Proposal for amendments to ECE/TRANS/WP.29/2020/81 complemented by ECE/TRANS/WP.29/GRVA/2020/32 and ECE/TRANS/WP.29/GRVA/2020/33

3rd Session of the Special Interest Group on UN-R 157

18 March 2021

03. Requiring a minimum following distance

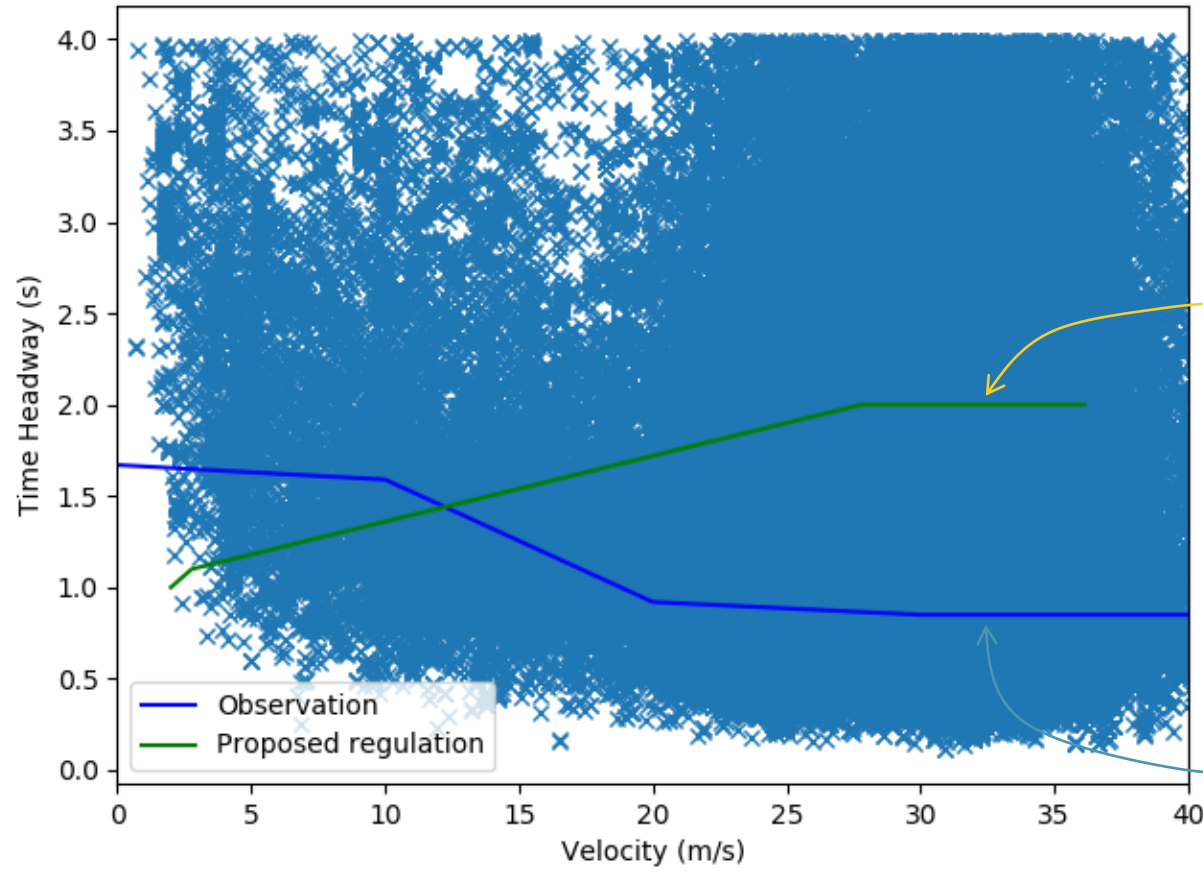
- Paragraph 5.2.3.3 currently requires a minimum following distance that the ALKS vehicle shall always respect. A table defining the distance to maintain per different speeds is defined
- In the proposed amendment for speed increase the table is extended to 130km/h
- In the proposed amendment for scope extension it is suggested to use additional tables for different vehicle categories

- The European Commission has already asked whether these tables are a proportionate requirement considering the following additional requirements
 - 5.2.3.3. The activated system shall detect the distance to the next vehicle in front as defined in paragraph 7.1.1. and shall adapt the vehicle speed in order to avoid a collision.
 - 5.2.5.1. The activated system shall avoid a collision with a leading vehicle which decelerates up to its full braking performance provided that there was no undercut of the minimum following distance the ALKS vehicle would adjust to a leading vehicle at the present speed due to a cut in manoeuvre of this lead vehicle.

- If the minimum safety distance comes from traffic rules, then they will be automatically respected by the fulfillment of the requirement on respecting traffic rules
- Since respecting the minimum distance is not a sufficient condition for safety, the only reason to request the respect of a minimum distance may be linked to the need not to confuse the other drivers

- Comparing the minimum distance with real-world data, the selected values (especially for speed higher than 60km/h) does not seem motivated.
- Keeping the requirement could
 - hinder innovation as ADS use cases focusing on short headways for fuel savings and traffic efficiency would not be allowed
 - expose the ALKS to (unnecessary) continuous cut-ins by other drivers with comfort and safety implications
- The EC proposal is therefore to remove the minimum following distance requirement

- The following proposal for amending par 5.2.3.3 is therefore introduced:
 - 5.2.3.3. The activated system shall detect the distance to the next vehicle in front as defined in paragraph 7.1.1. and shall adapt the vehicle speed in order to avoid a collision.
 - ~~deleted~~
 - In case **this** cannot be respected temporarily because of other road users (e.g. vehicle is cutting in, decelerating lead vehicle, etc.), the vehicle shall readjust the following distance at the next available opportunity without any harsh braking unless an emergency manoeuvre would become necessary.
 - ~~deleted~~
 - **The requirements of this paragraph are without prejudice to other requirements in this Regulation, most notably paragraphs 5.2.4. and 5.2.5. with subparagraphs.**

Time headway distributions per speed interval on pairs of vehicles proceeding at constant speed*

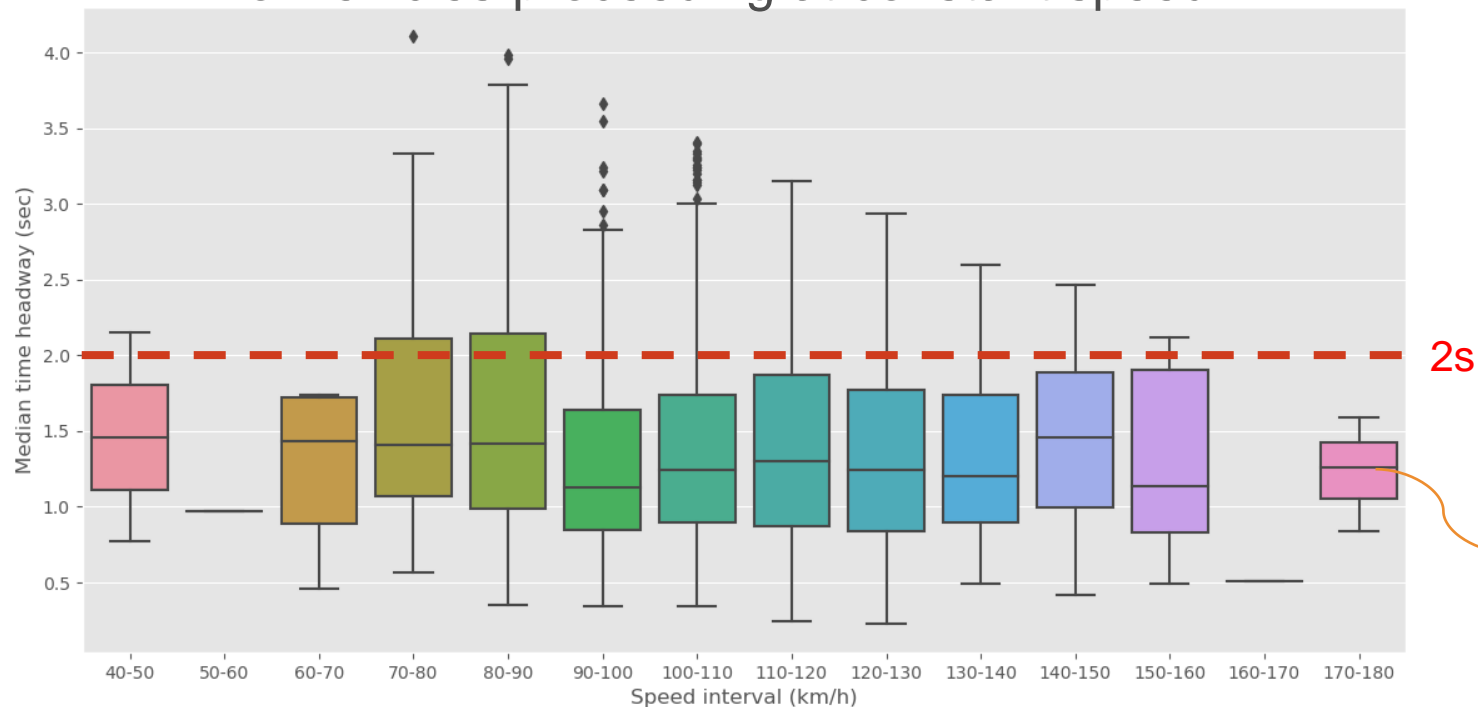
Median headway always shorter than 1.5s

Cut-in

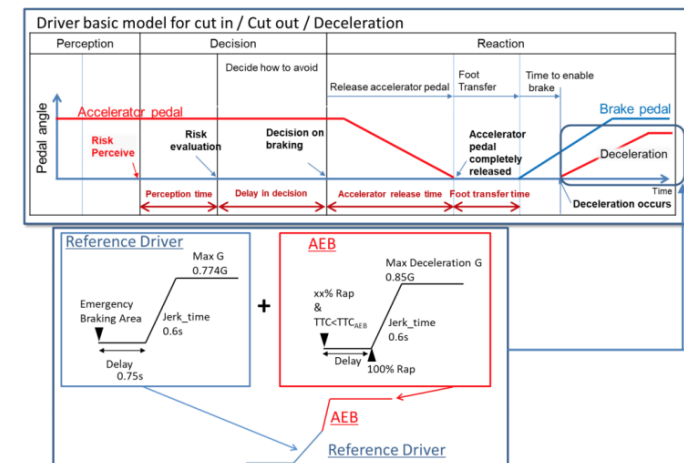
- 5.2.5.2. The activated system shall avoid a collision with a cutting in vehicle,
- Provided the cutting in vehicle maintains its longitudinal speed which is lower than the longitudinal speed of the ALKS vehicle and
 - Provided that the lateral movement of the cutting in vehicle has been visible for a time of at least 0.72 seconds before the reference point for $TTC_{LaneIntrusion}$ is reached,
 - When the distance between the vehicle's front and the cutting in vehicle's rear corresponds to a TTC calculated by the following equation:

- The performance model of Appendix 3 to Annex 4 does not show any condition for which car-following and cut-out would generate an accident. Therefore the only actual performance requirement is introduced for cut-in
- The two proposed performance models are equally valid approaches to determine “unpreventable” cut-ins
- Their only limitation is to always treat the cut-in as an “emergency” situation in which the vehicle has either to do nothing or to apply maximum deceleration capabilities
- In reality humans (as well as the future ADSs) apply proportionate reactions and count very much on anticipation (***tactical safety***)

- For the above considerations an amendment proposal is introduced to
 - Limit the use of the performance model only to cut-in
 - Have only 1 model left in the regulation (the EC proposal) fully described in Appendix 3
- Paragraph 5.2.5 and Appendix 3 have been amended to introduce these changes
- The EC is also available to produce an open software implementation of the performance model and to keep it on a public web-site

04. Performance requirement for car-following, cut-in and cut-out

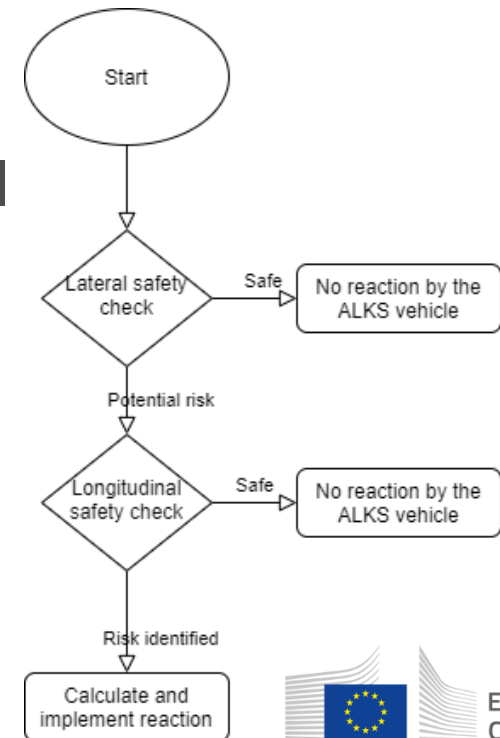
- In order to achieve a proper assessment of the “unpreventable” cut-in scenarios, a proposal for a slightly different performance model based on “fuzzy-logic” to mimic tactical safety behavior is introduced
- The model first performs a lateral safety check
- If a potential risk is identified it performs a longitudinal safety check
- If the potential risk is confirmed a proportionate reaction is applied

04. Performance requirement for car-following, cut-in and cut-out

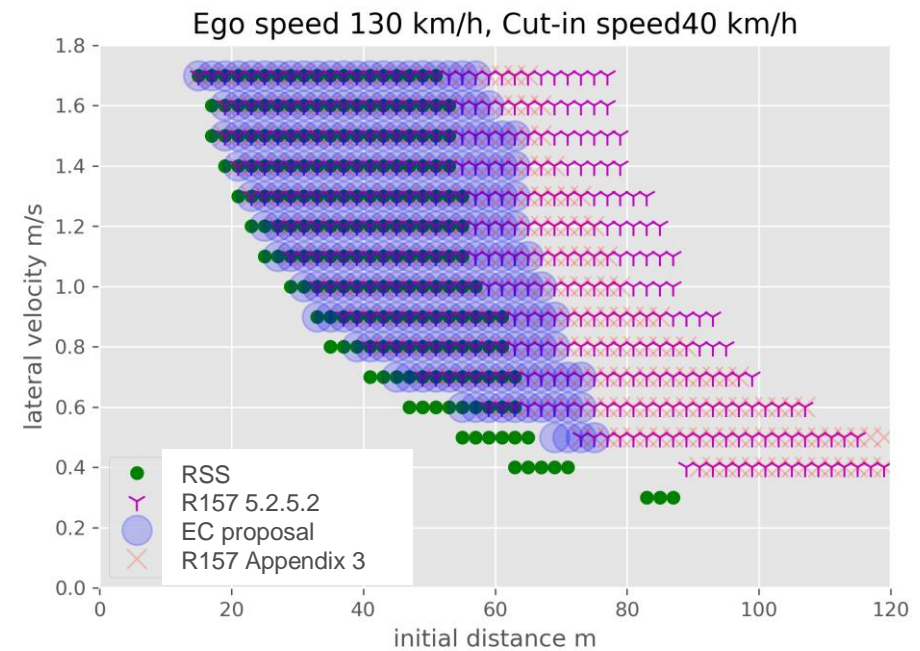
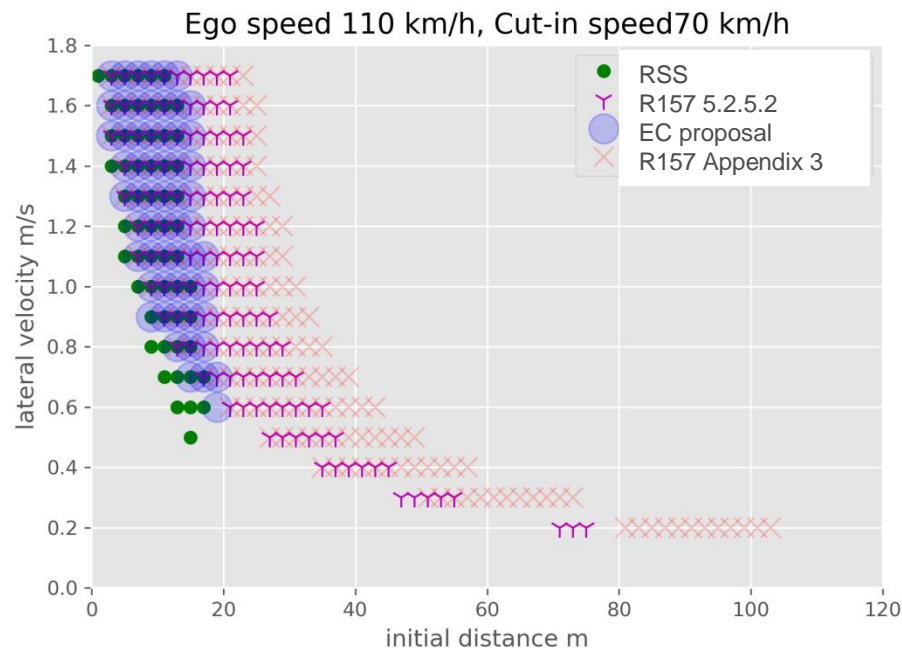
- Using the same values of the parameters suggested by the performance model of Appendix 3, by only changing the driving logic, a significant reduction in the number of “unpreventable” cases is achieved
